## PRODUCER STATEMENT – PS1 – DESIGN

**IN RESPECT OF:** KiwiSpan Shed (DSL Reference: KS19823)  
(Description of Building Work)

# GoGet Processing Summary Report

Description: AMENDMENT: Addition to Dwelling of a Kiwispan Garage

sheet no:  
**A2-2**

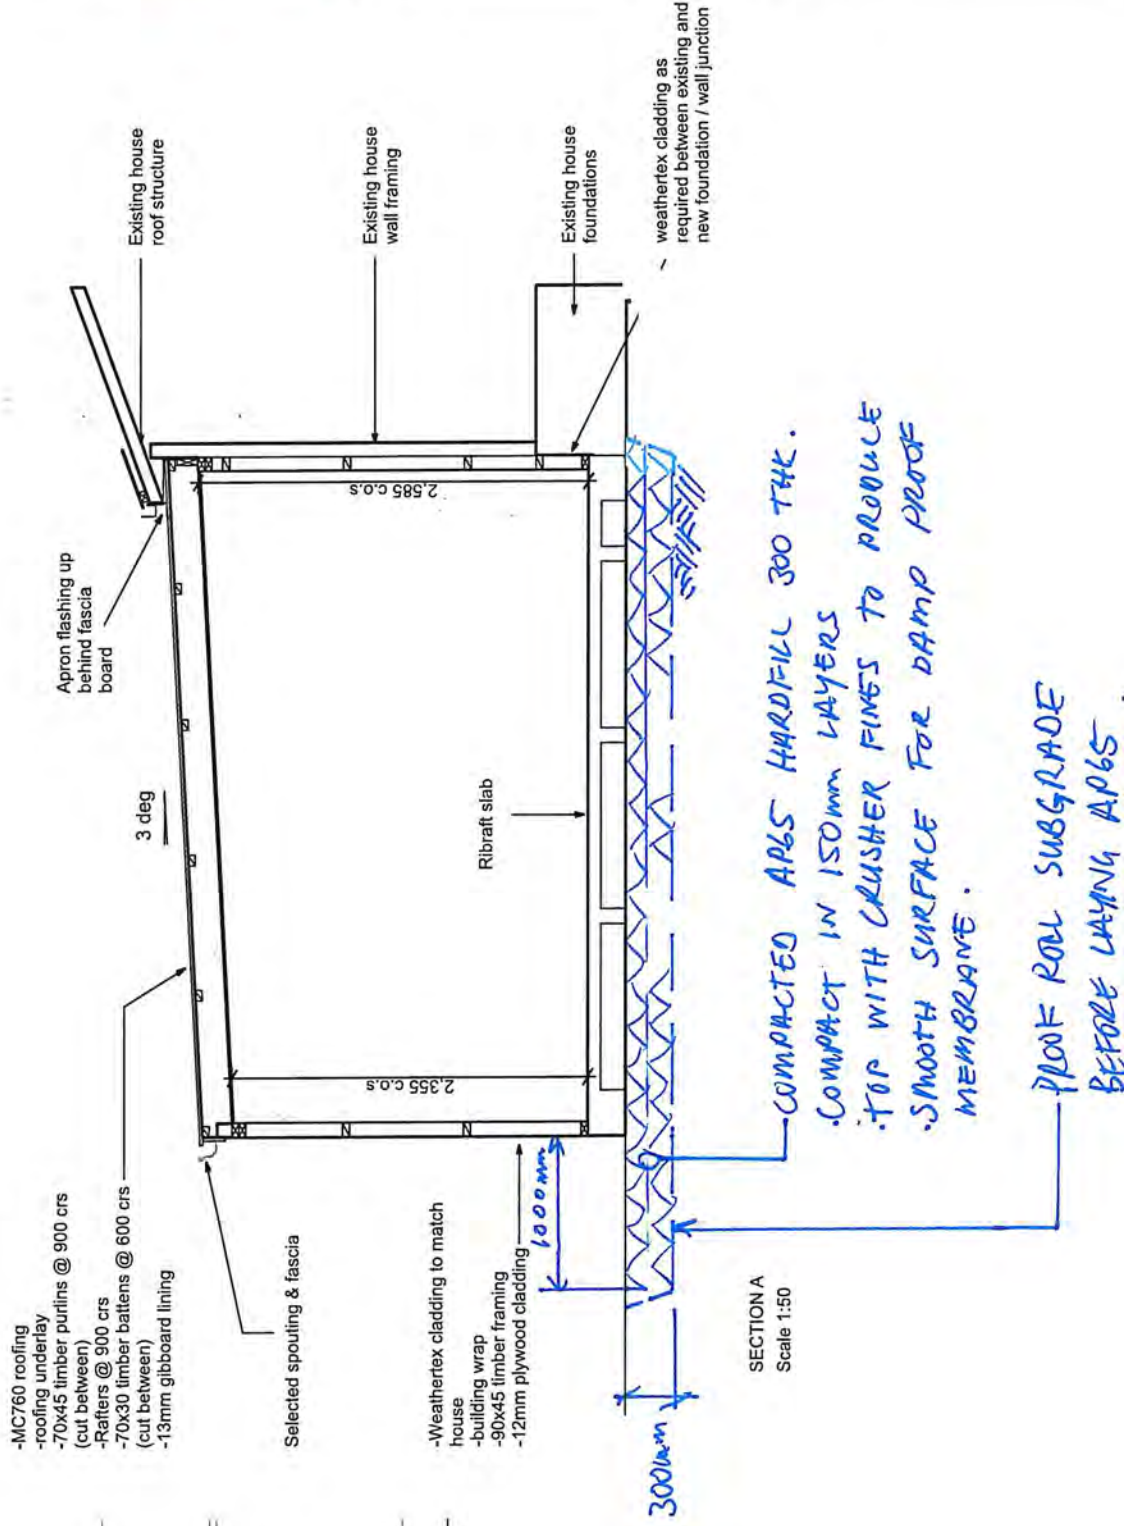
- REFER MARKED UP PLANS ATTACHED.
- SUITABLY QUALIFIED ENGINEER TO INSPECT CLEARED SUBGRADE AND FINAL COMPACTION.

USE 300THK THRU-FILL RAFT.
